Date: February 4, 2021

Reference: WA567-46F01(rev2)- WE Letter

**RE: TOWER R4A, ONE SYDNEY HARBOUR, BARANGAROO
PEDESTRIAN WIND ENVIRONMENT LETTER TO REVIEW THE WIND
IMPACT OF THE CURRENT TOWER R4A PODIUM LANDSCAPE LAYOUT**

Figure 1: Study Point Locations and Target Wind Speed Criteria - Level 02 Terrace

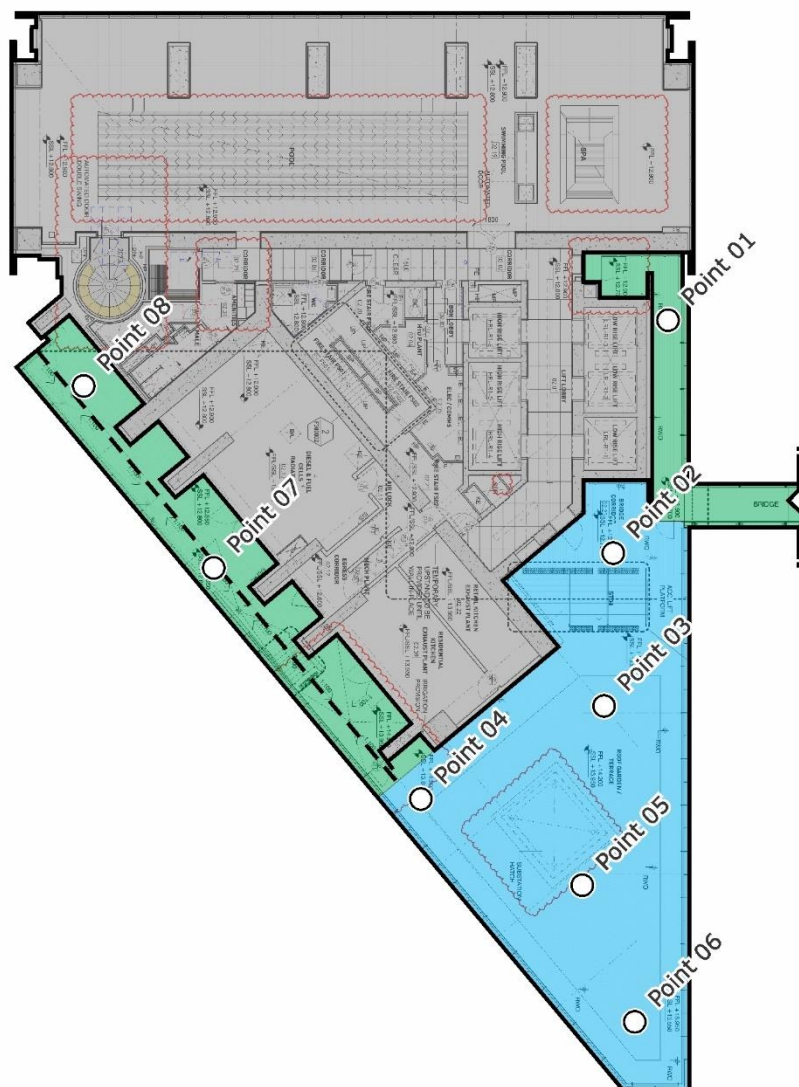
"Provide a Wind Impact Statement confirming that the revised layout of the podium level landscaping will provide acceptable wind mitigation outcomes for future users of the podium. Notably the 3m high screen, which formed part of the approved podium landscape plan, does not appear to form part of the proposed podium landscape design."

The results of the study show that the wind conditions on the Level 2 podium of Tower R4A will be mostly suitable for their intended uses. However, some areas will experience strong winds which exceed the relevant criteria for comfort and/or safety. Only the area represented by Point 03 experiences wind conditions that exceed the both the safety limit and comfortable walking criterion.

The revised landscape layout of the podium landscaping has been considered by Windtech. We believe that the landscape will provide some mitigation of the effect of the westerly winds. Furthermore, to address the safety limit exceedance at Point 03, a wind speed sensor will be installed to monitor the wind conditions and provide immediate feedback to the building's BMS system, which would block access to the Level 2 terrace when winds approach the safety limit.

Figure 1: Recommended location of the wind speed sensor

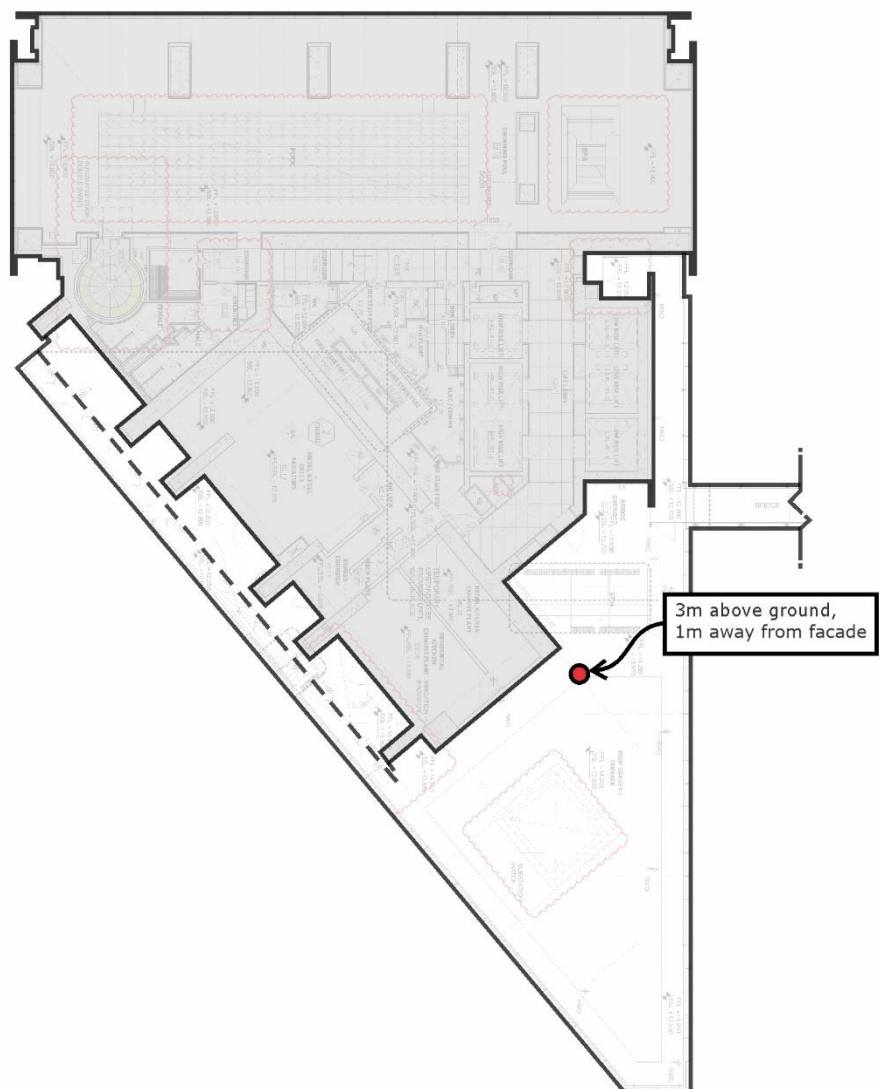
It is proposed that a wind speed sensor is placed at the critical location, as shown in Figure 2, below. Note, that while this is the optimal location, there is some flexibility in the location of the sensor and can be relocated upon careful consideration of the local wind environment of the terrace and approval from Windtech.

It is suggested that a red light turns on when the wind conditions at Point 03 exceed 11.3m/s with the following message "strong wind conditions do not exit". It is also recommended that an alert be given to building management to evacuate and close off the terrace once the 1-minute mean readings exceed 16m/s (equivalent to a 3-second gust of 21m/s or a 0.5 second gust of 24m/s).
